CITY OF MILPITAS

Re: Integral Centre Pointe Mixed Use Project

Building Design Comments
CENTRE POINTE LOTS B & C

Mixed Use Comments
CENTRE POINTE

Auto Alley Landscape Examples

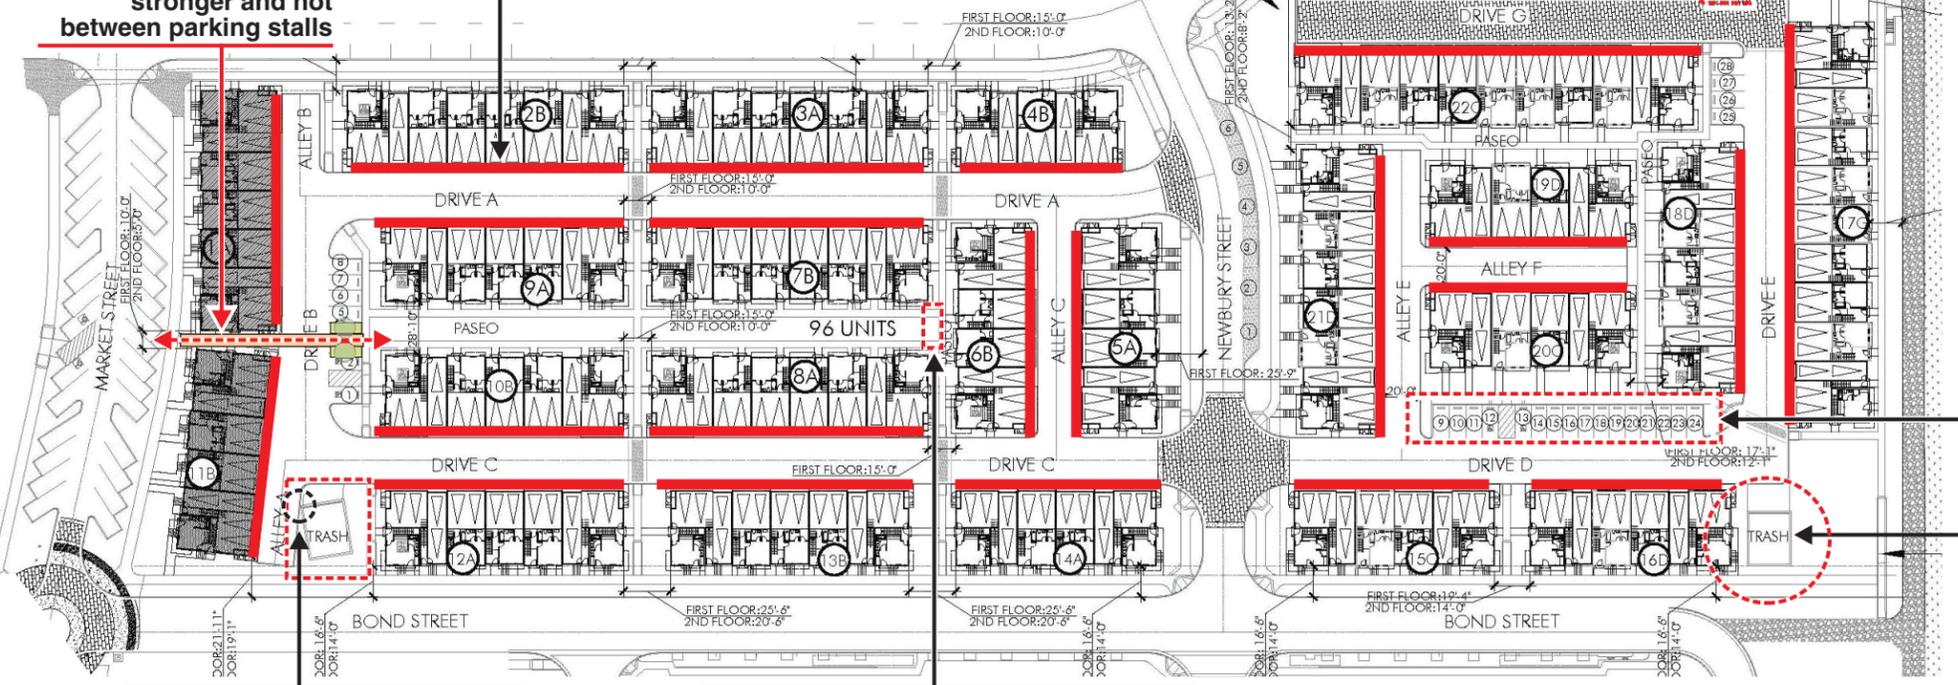
Pedestrian connection from Guest Parking on Market Street should be stronger and not between parking stalls

Examples above show two ways to modulate the auto alley environment

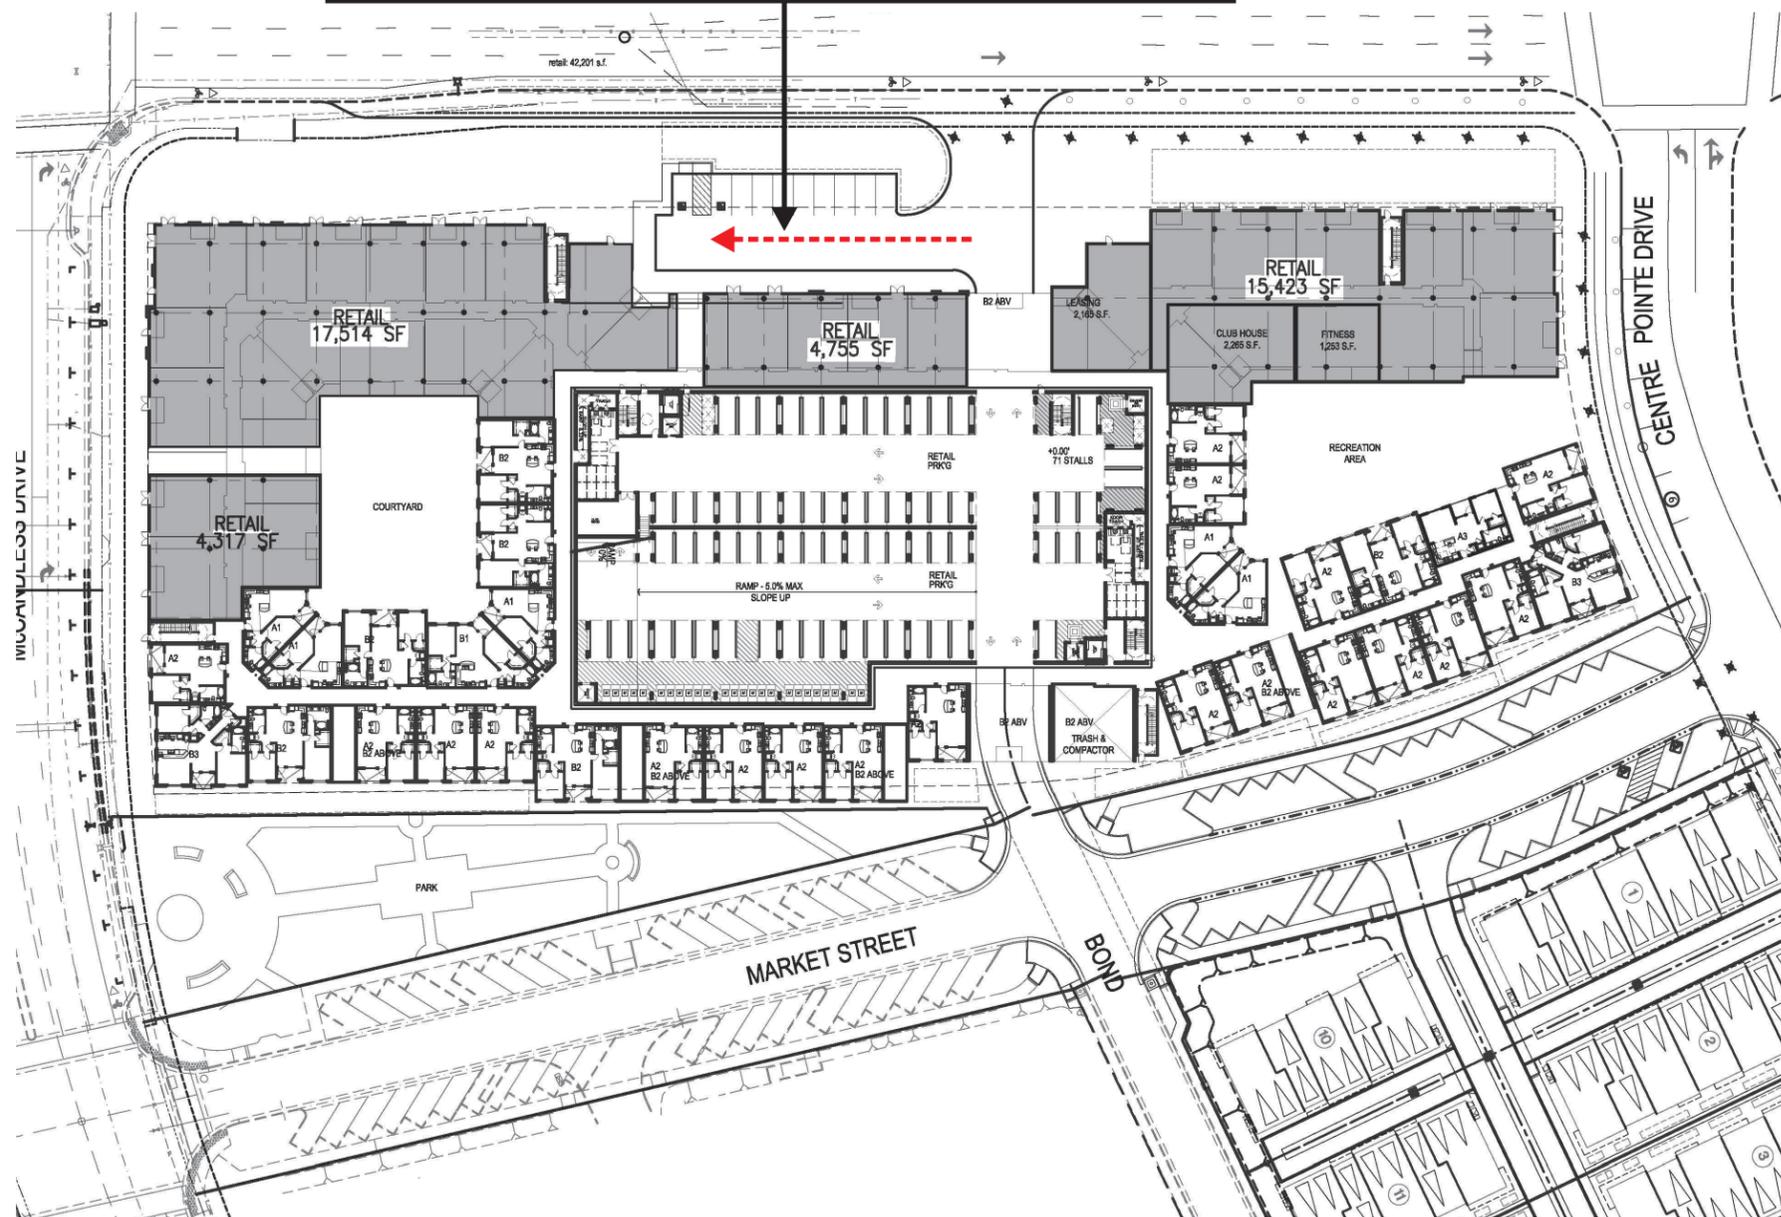
Rear elevations have long rows of unbroken garage doors and flat facades broken only by awnings
Residents will probably experience this environment more than the front elevations

Front elevations have good modulation and detail to provide feeling of individual units

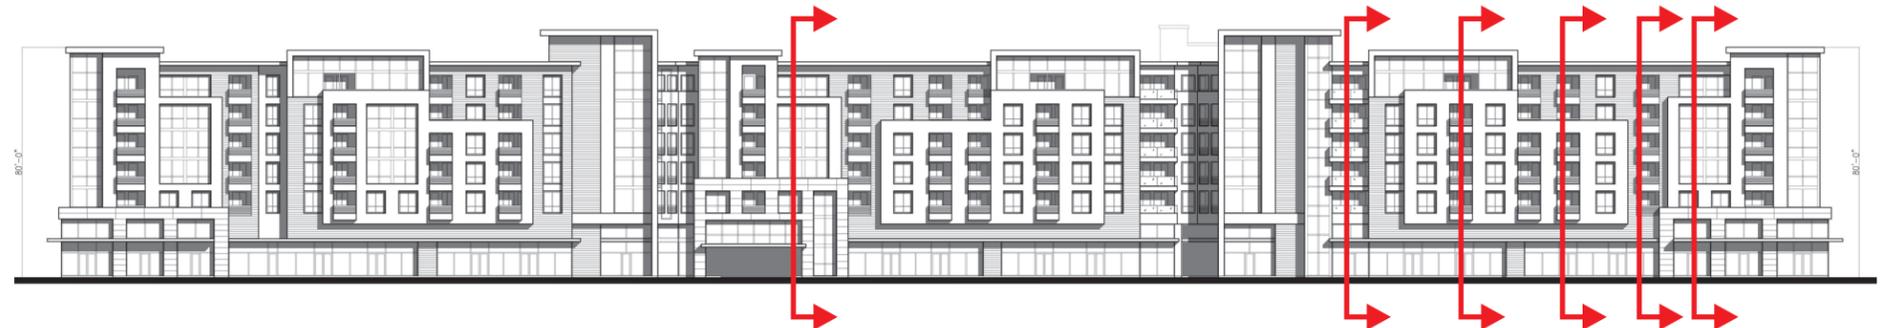
Dead end parking lots are not optimal
Parking for retail will be tempting.
Consider additional curb cut which would allow this to also be used a passenger drop-off area.

Very difficult to see from the drawings provided whether facades have significant wall plane offsets or whether it is mostly surface decoration
Several larger scale, accurate wall sections for all facades would be desirable.
